SUBJECT: Fuel sender and fuel tank deformity

CONDITION: Fuel gauge may show less fuel than is in tank

APPLIES TO: This bulletin applies to MM, K3, K2, and NVS model motor home chassis manufactured between April 24, 2002 and April 6, 2015.

CORRECTION: Adjust fuel sender float arm

FIG. 3-1

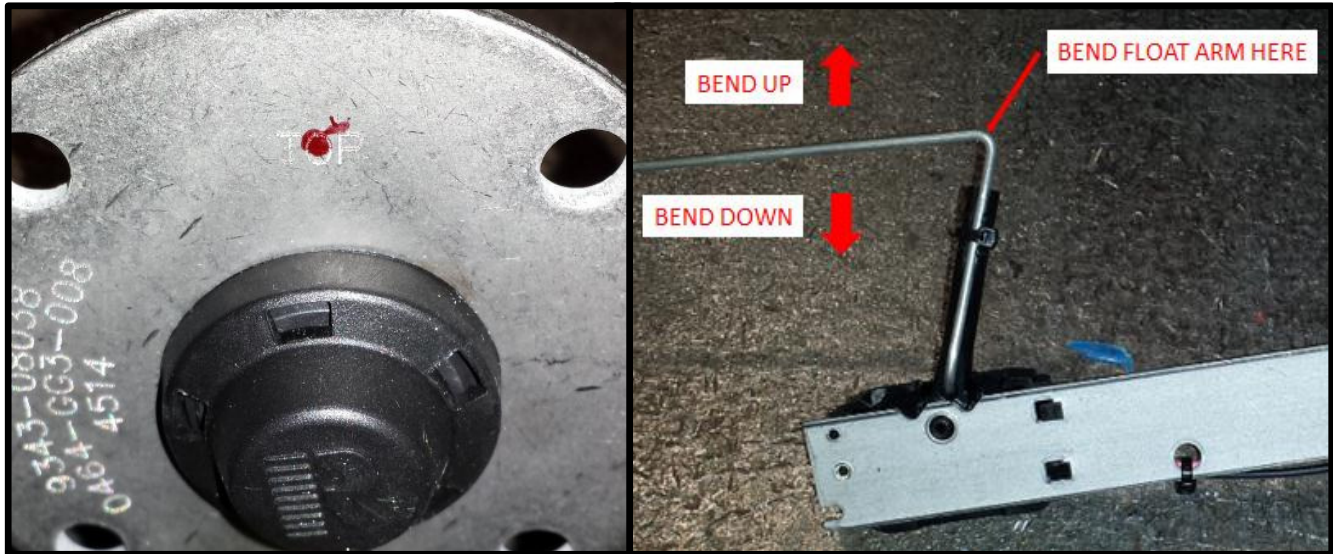
8. Remove fuel sender from tank.
9. Bend float arm at bend location – float arm will be adjusted according to Ohm measurement from initial reading. If Ohm reading is higher than the required reading the arm needs to be bent down, if the reading was less than the required reading the arm needs to be bent upwards.

- a. Sender is labeled TOP as would be installed into tank. Refer to FIG. 3-1.
